Addendum No. 04

The Construction of Crosby Sixth Grade Campus

Crosby ISD RFP# CSP 2526-0002

Addendum Number Four (04)
TO PLANS AND SPECIFICATIONS for
Crosby Sixth Grade Campus For Crosby ISD
STANTEC Project No. 214001329

A5 / A141D **FURNITURE PLAN - LEVEL 1 - AREA D**
1/8" = 1'-0"

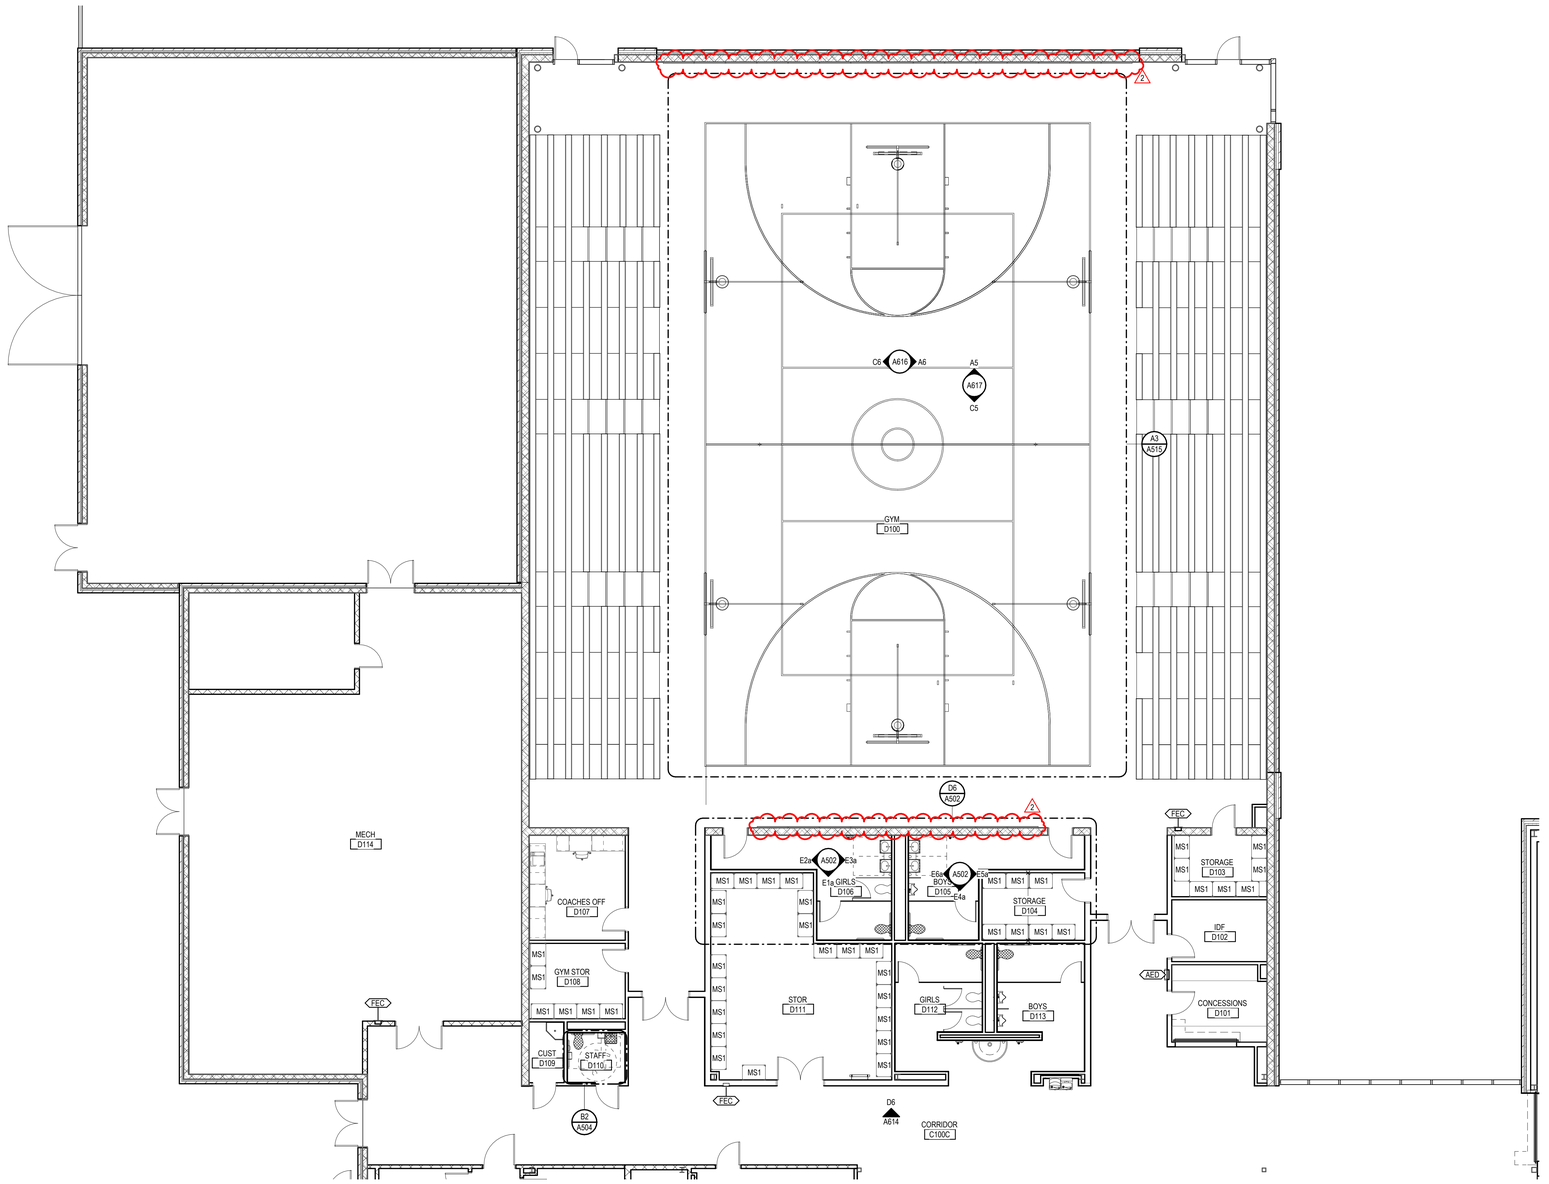
20. Sheet A141C:
    - **Added** Elevation and note to plan to clarify instrument locker's locations.
21. Sheet A141D:
    - **Added** Additional wall pads.

A5 / A142A — **FURNITURE PLAN - LEVEL 2 - AREA A**
1/8" = 1'-0"

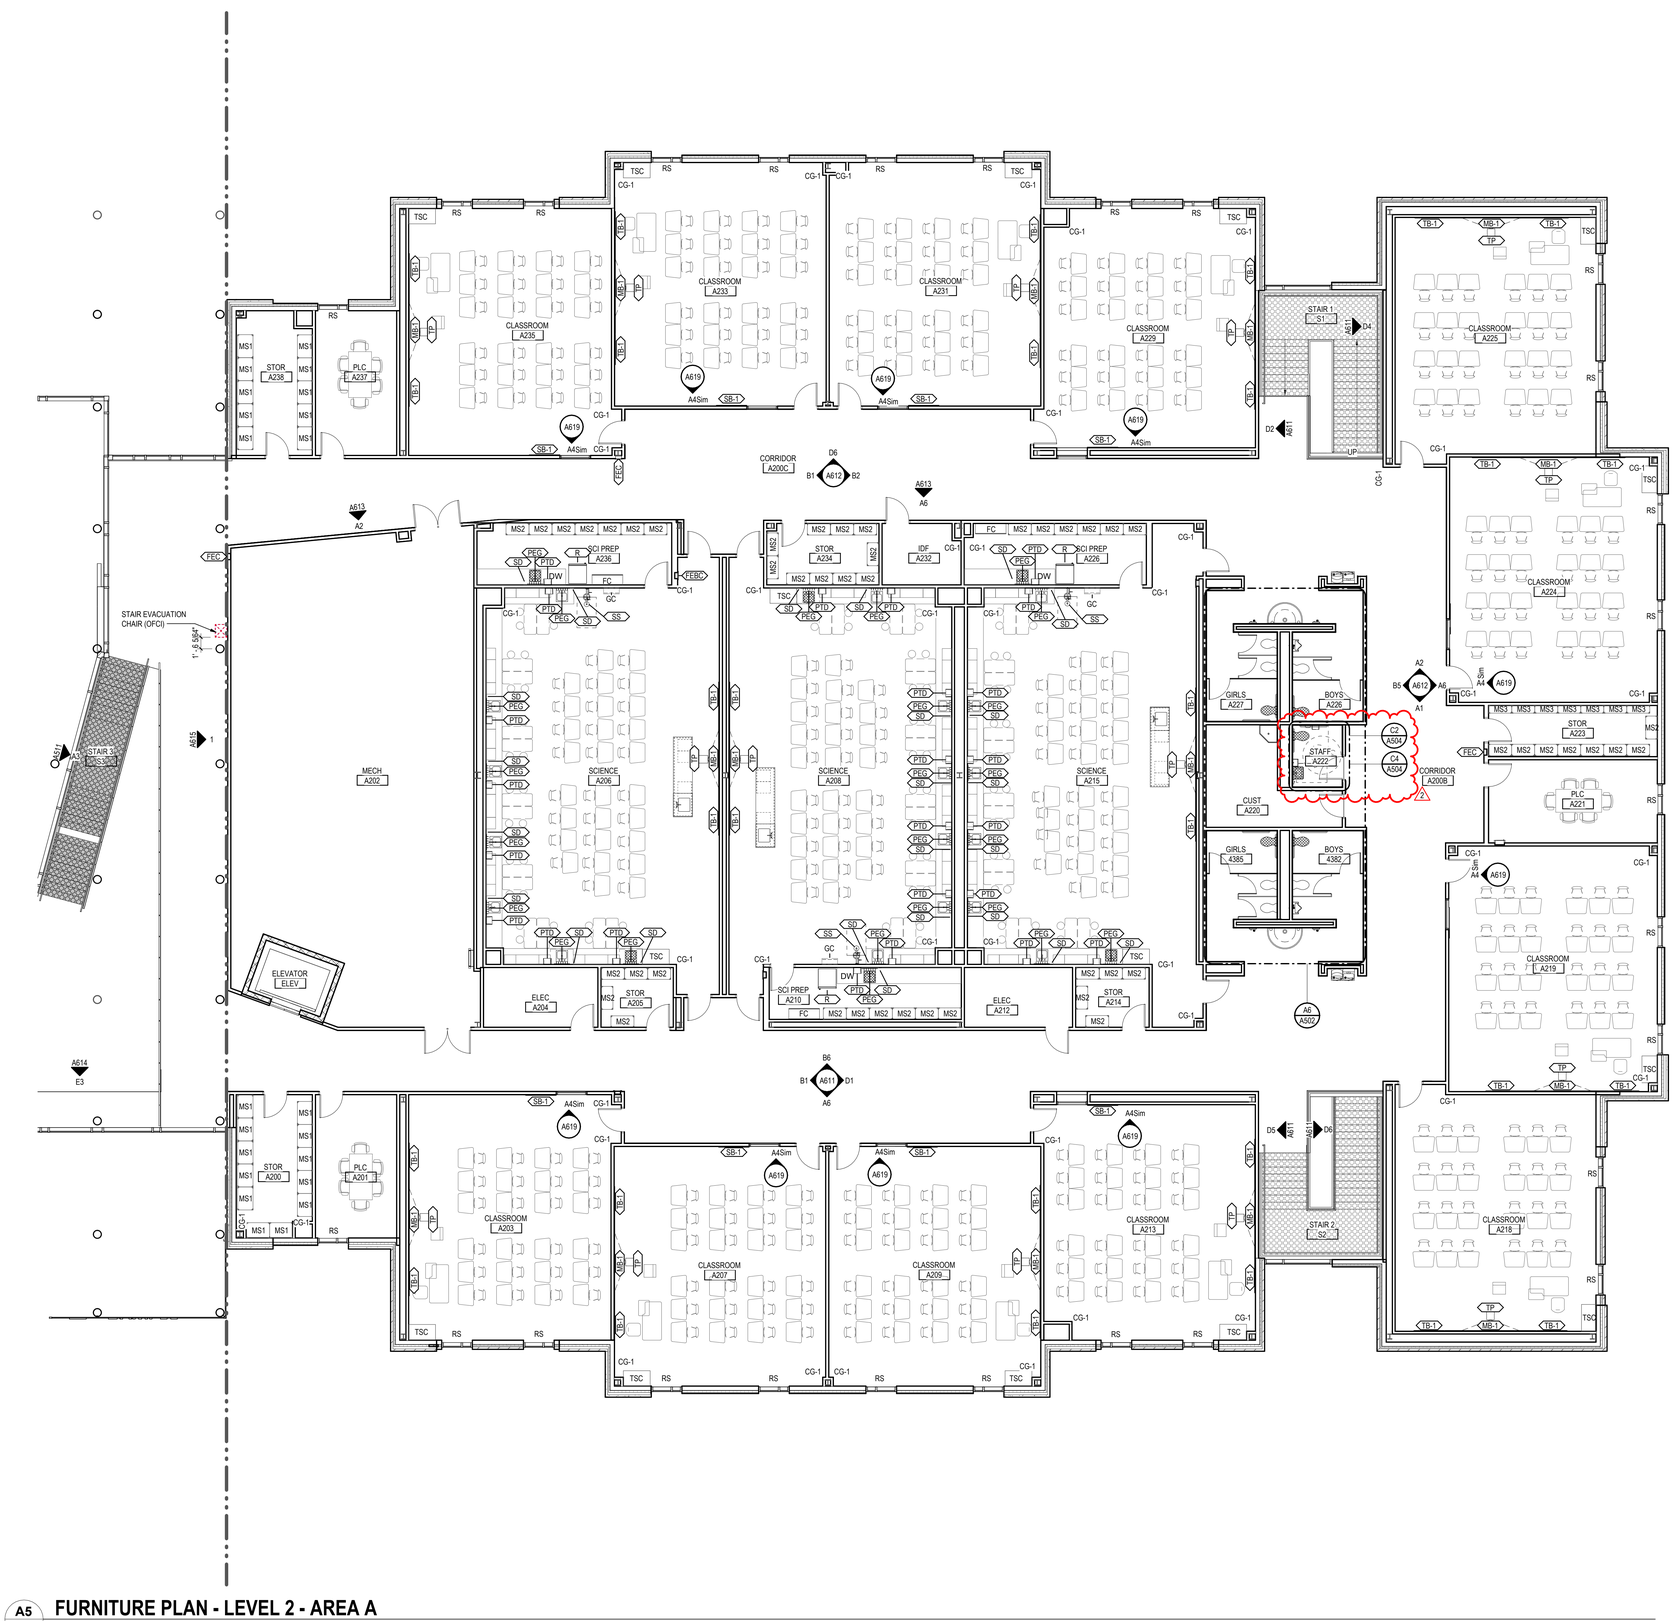
22. Sheet A142A:
    - **Added** Enlarged plans.
23. Sheet A211:
    - **Updated** soffit panel and metal panel color and profile. Ref: RFI note 44
24. Sheet A212:

Project No. 214001329
Scale As indicated
Revision 2
Drawing No. **A212**

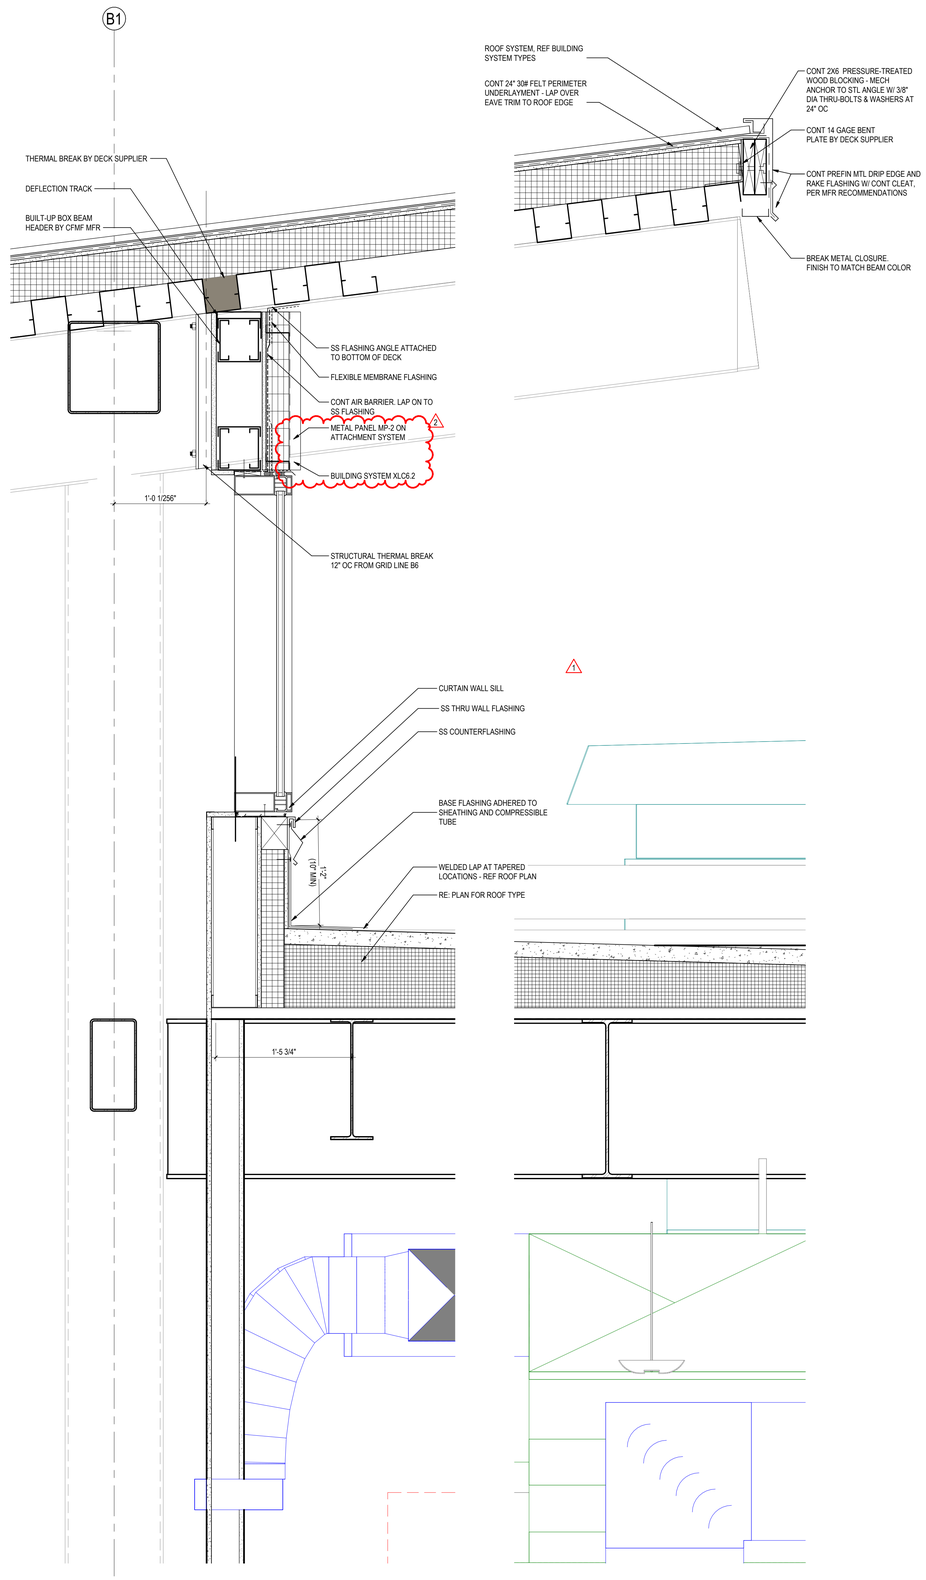
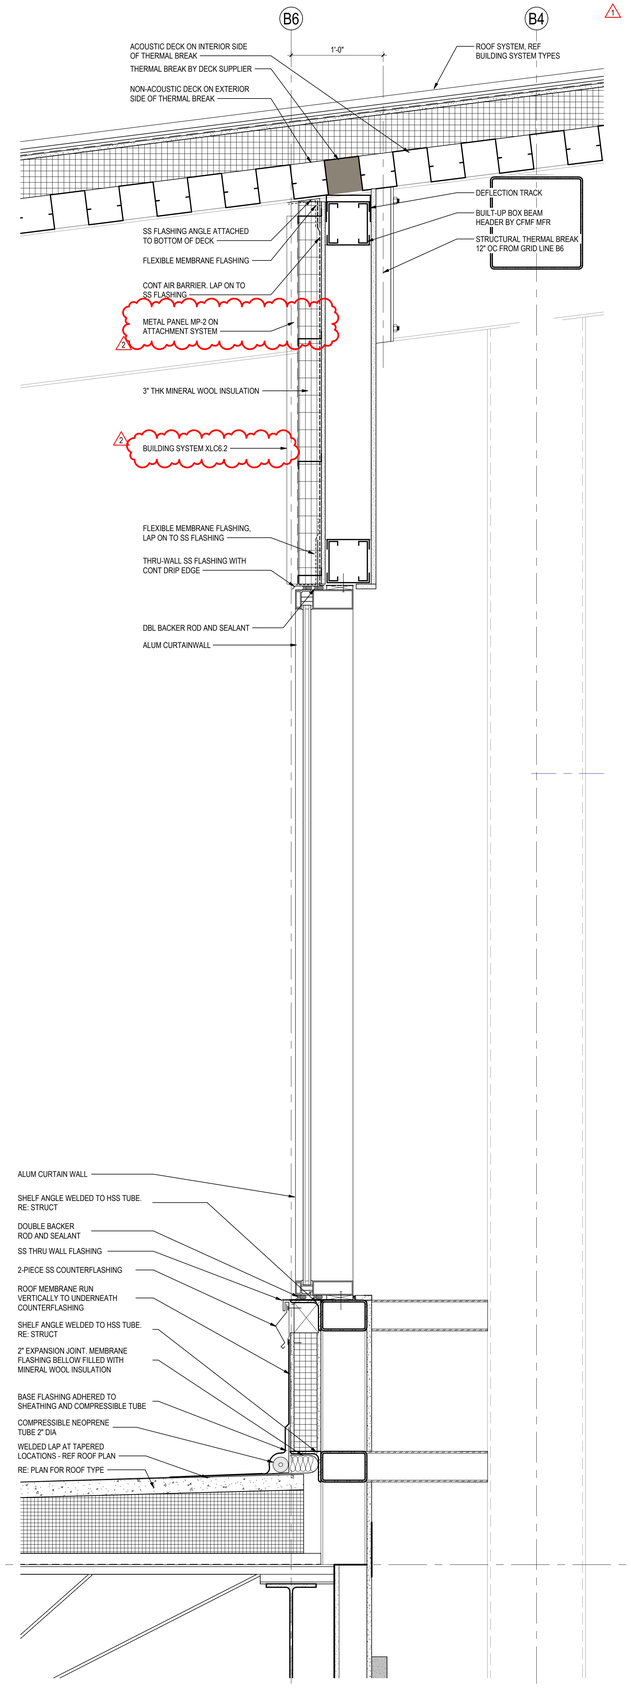
Q: Revise Material Legend on sheet A212 to reflect basis of design panel profile.

Q: Revise MP1 Pattern Legend on sheet A212 to reflect basis of design panel profile.

R: Sheet A211 submitted for pricing contains the material schedule with MP-1 and MP-2 profiles called out.See updated attached sheet A212 with metal panel profiles called out. (INTERNAL HL IS WORKING WITH BERRIDGE REPS TO GET CORRECT PROFILES)

R: Addendum #4 will contain updated drawing A1/A212 using HR-4 and HS-8 panels.

C6 A512 **DINING PROSCENIUM - SOUTH**
1/4" = 1'-0"

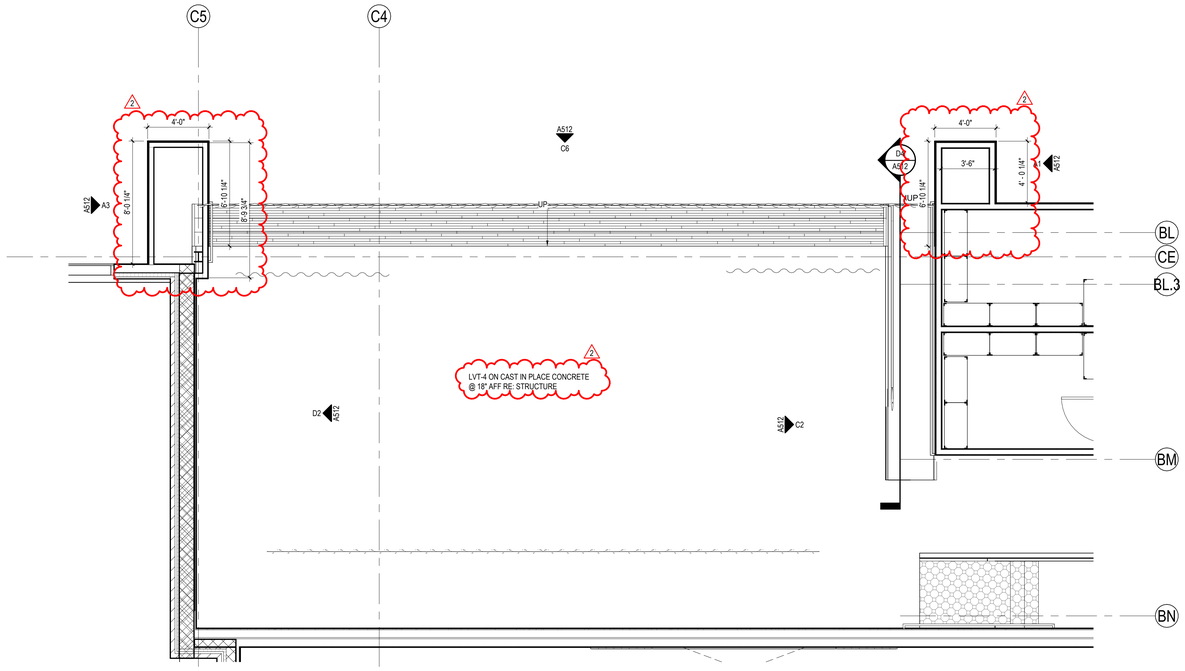
32. Sheet A503:
    - **Updated** Sheet reference number.
33. Sheet A504:
    - **Updated** Enlarged plans added for information.
34. Sheet A512:
    - **Revised** Dimension for clarity.

D3 / A516 **DINING STAGE - WEST - ALT**
1/4" = 1'-0"

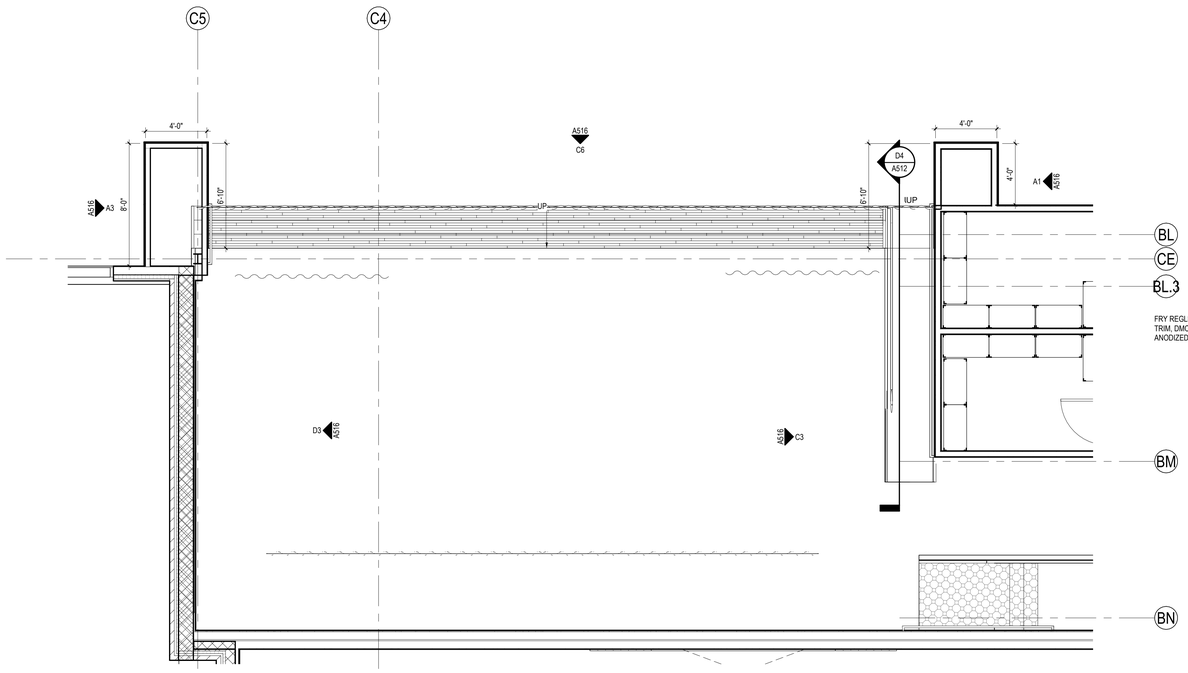
- **Updated** Dimension.
    - **Updated** Finish.
    - **Updated** Dimensions.
35. Sheet A516:
    - **Added** Enlarged plan and elevations added for alternate material.

C5 / A617 **GYM D100 - SOUTH**

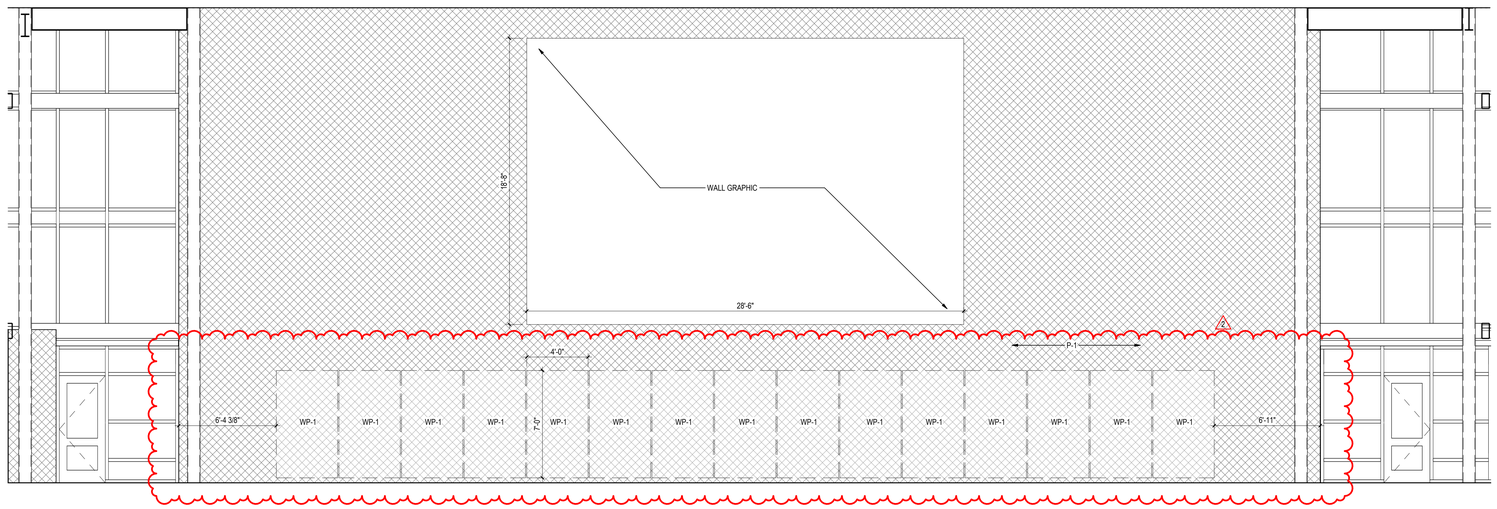
Scoreboards: How many 1 or 2 ? Not shown on the interior elevation drawings.

There is only 1 scoreboard. Documents have been updated in Addendum 02 to reflect this.

- **Revised** Ceiling type changed.
38. Sheet A617:
    - **Updated** Scoreboard added, projection screen moved, and additional wall pads added.
39. Sheet A618:

Project No. 214001329
Scale As indicated
Revision 2
Drawing No. **P311C**

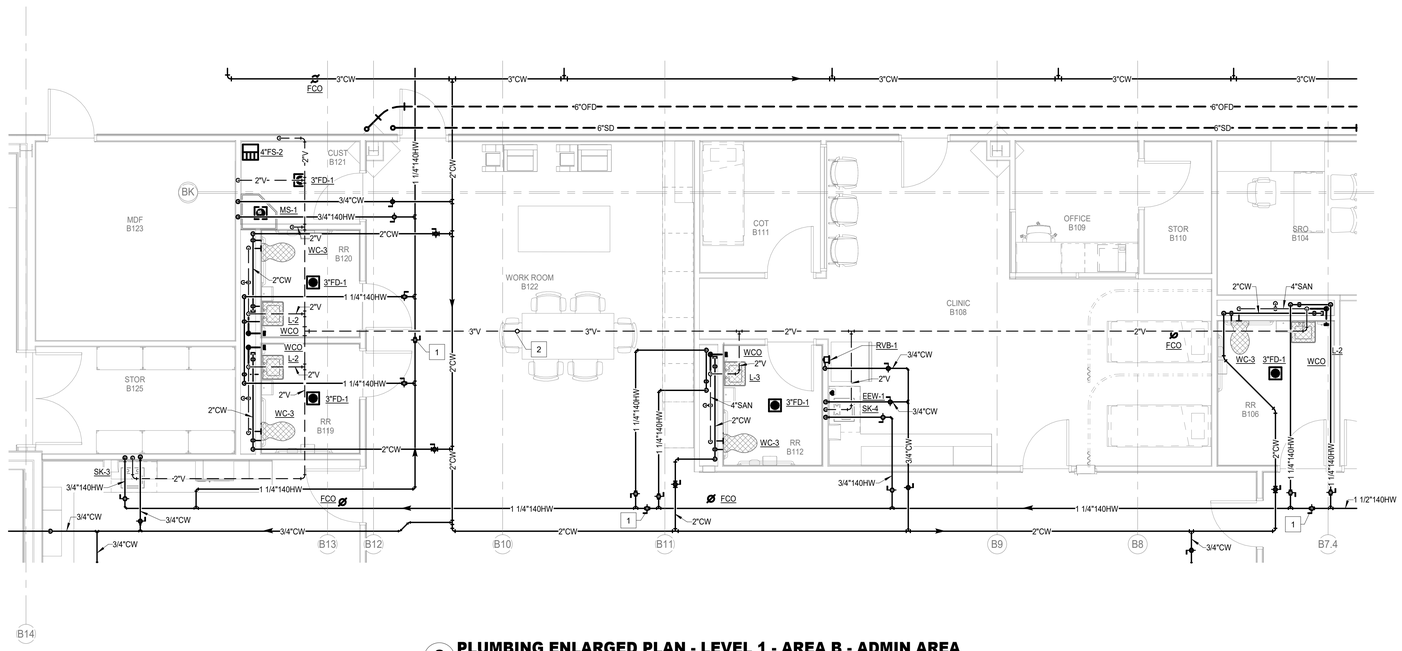
RFI 2: According to Drawing P311C, the Storm Drain and Overflow are 8", but the RD-1 and RD-2 that connect to this on P412C are 6". Please advise.

Q: According to Drawing P311C, the Storm Drain and Overflow are 8", but the RD-1 and RD-2 that connect to this on P412C are 6". Please advise.

RFI 2: Storm piping to be revised by addendum to be 6" and not an 8".
